MSA-5-1829-5518

Comments
10/26/06
KS

October 26, 2006

Re: 2006-0358-V; 201 McLean Place
James Landas

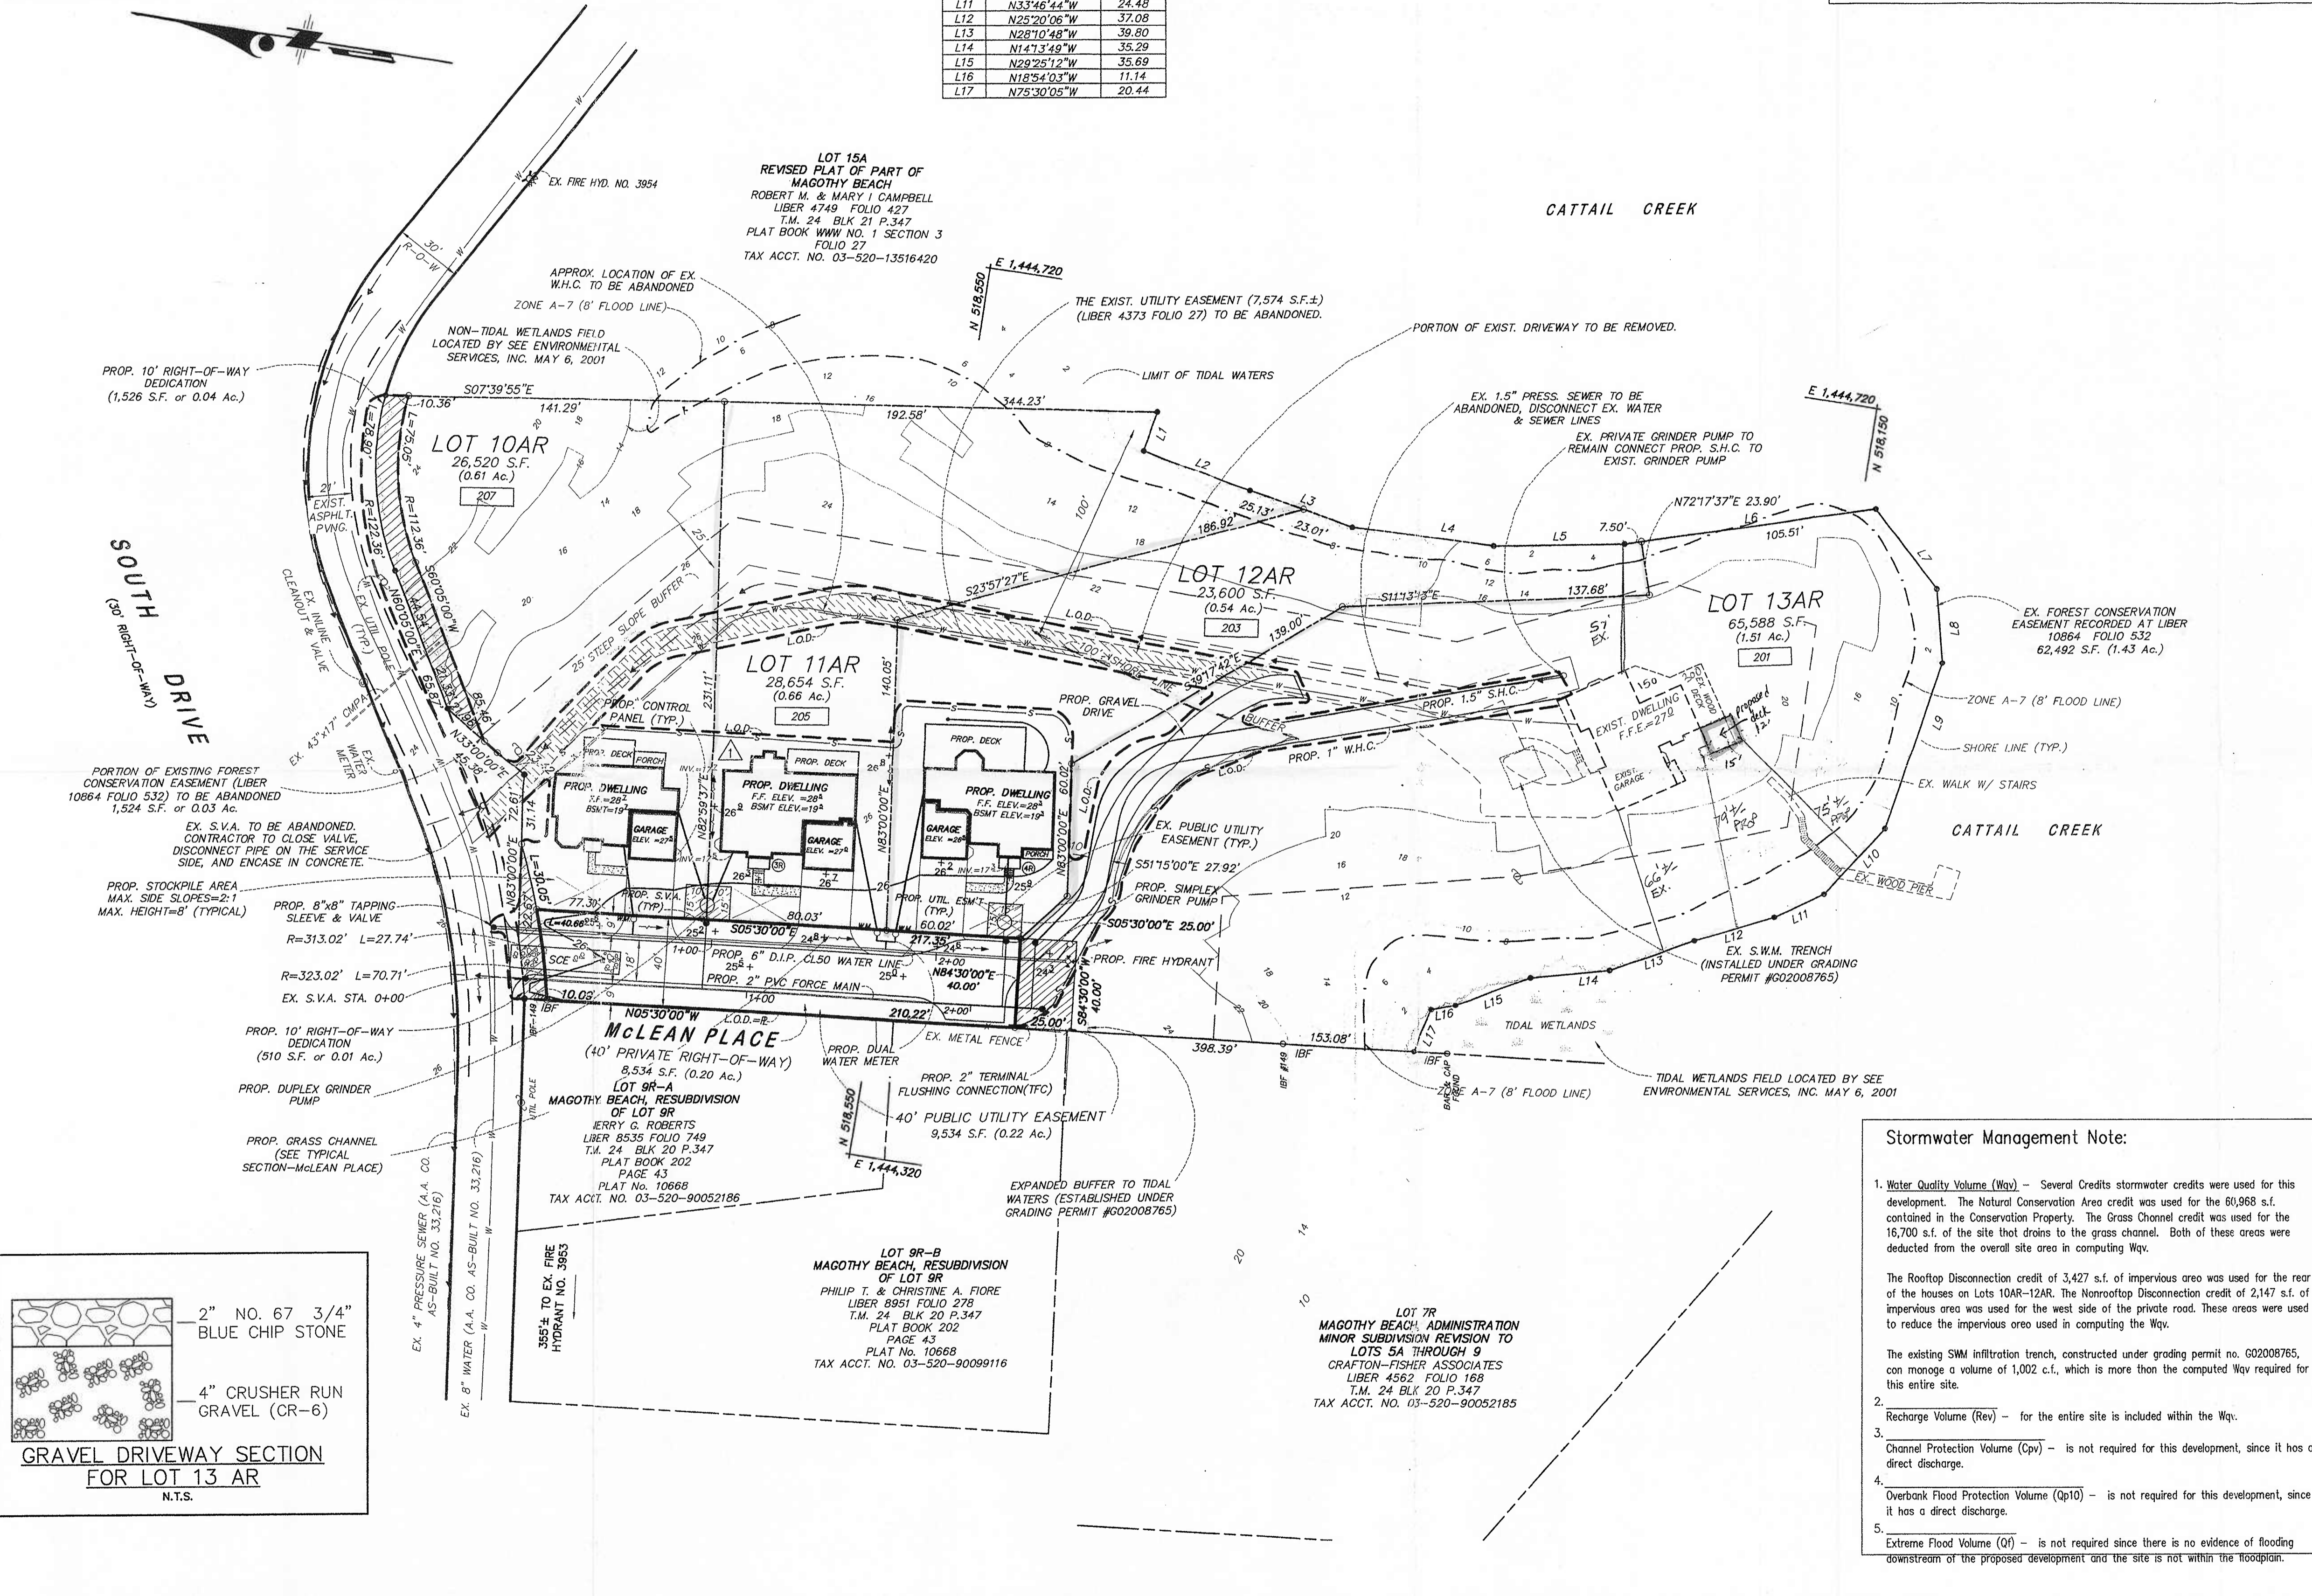
Thank you for providing information on the above referenced variance. The applicant is requesting a variance to allow a dwelling addition (deck with hot tub) with less Buffer than required. The lot is 65,588 square feet in size, designated as Limited Development Area (LDA) and is entirely within the 100-foot Buffer.

Based on the information provided, this office would not support this variance request. In this instance, the applicant is proposing to increase the size of deck in the Buffer and proposes to install a hot tub. The applicant already has significant deck space available, approximately 450 square feet, waterward of the dwelling (see attached image). The proposed expansion is 180 square feet in size, of which 50 square feet will be impervious surface. In 2002 and 2004, the Maryland General Assembly reiterated its commitment to the protection of the water quality and habitat of the Chesapeake and Atlantic Coastal Bays Critical Area by strengthening and clarifying the Critical Area law, especially emphasizing the importance of the 100-foot Critical Area Buffer. In particular, the General Assembly stated that variances to a local jurisdiction's Critical Area program may be granted only if a zoning board finds that an applicant has satisfied the burden to prove that the request meets each one of the County's variance standards, including the standard of "unwarranted hardship." The General Assembly defined that term to mean that without the variance, the applicant would be denied reasonable and significant use of the entire parcel or lot. I do not believe the applicant can meet the standard of unwarranted hardship given that they already enjoy significant outdoor use of their property.
